January 28, 2019

Subject: Comment – Tentative Order R9-2019-0003

Prepared For	POSEIDON WATER CARLSBAD DESALINATION PLANT
Prepared By	ERIC MILLER MILLER MARINE SCIENCE & CONSULTING, INC ALISO VIEJO, CA
Date	JANUARY 2019
Application Appendix Number	GGG-R2

**Independent review: TOPICS FOR NEUTRAL THIRD PARTY REVIEW IN SUPPORT OF THE REISSUANCE OF THE NATIONAL POLLUTANT DISCHARGE ELIMINATION SYSTEM (NPDES) PERMIT FOR THE CARLSBAD DESALINATION PLANT**

**Figure 1: Relationship between Impingement and MGD for 50 “ordinary” events.**

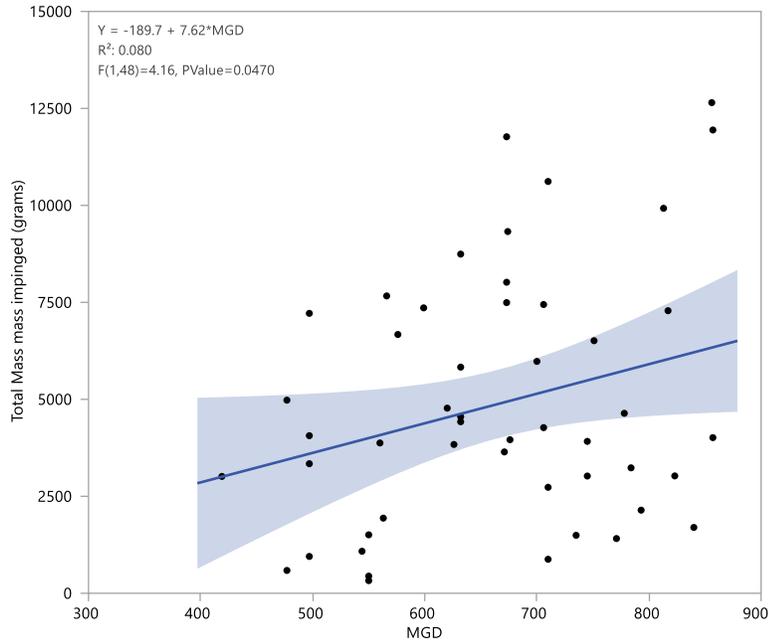
The relationship depicted in figure 1, as expected, shows an increase in impingement as MGD increases. However the relationship is much weaker than expected. This is due to the high level of simple temporal variability in impingement unrelated to flow (e.g. pulses of individuals near the intake structure). Adding the two extraordinarily high impingement events corrupts the relationship entirely (see figure 2 below).

**Figure 2: Relationship between Impingement and MGD for 50 “ordinary” (red) and “extraordinary” events (blue).**

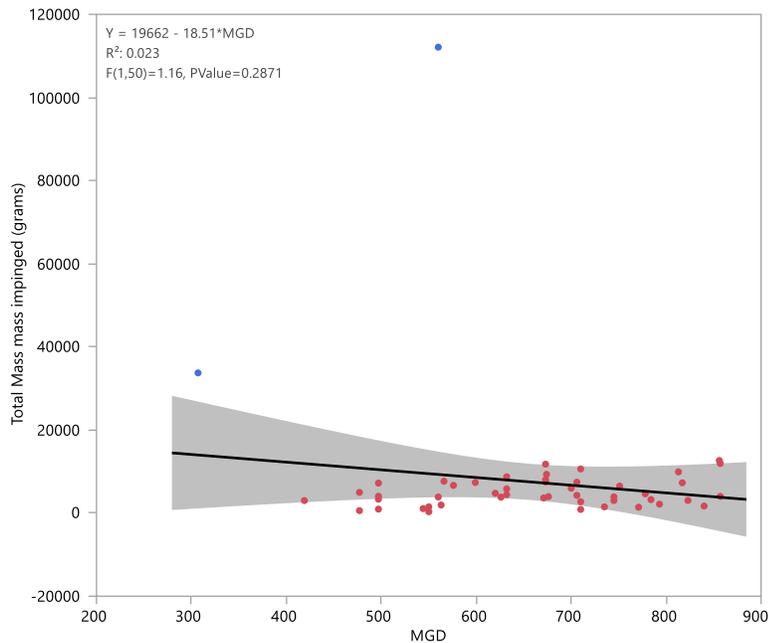
Including all 52 events causes the relationship to shift from positive (figure 1) to negative (figure 2). Note that the relationship is significant in figure 1 ( $p = 0.047$ ) but not in figure 2 ( $p=0.2871$ ). It is clear that the inclusion of all data corrupts the relationship between MGD and impingement. Nordby recognized this and derived an estimate of impingement related to CDP MGD that was based on a hybrid approach. The 50 ordinary events were calibrated by the MGD ratio noted above and the 2 extraordinary events were not. This led to an estimated daily impingement rate of 4.7 kg per day (=10.36 lbs per day). For comparison, calibrating all the data and using the relationship shown in figure 2, the estimate for 304 MGD would have been 14.03 kg per day (at the 50% confidence limit).
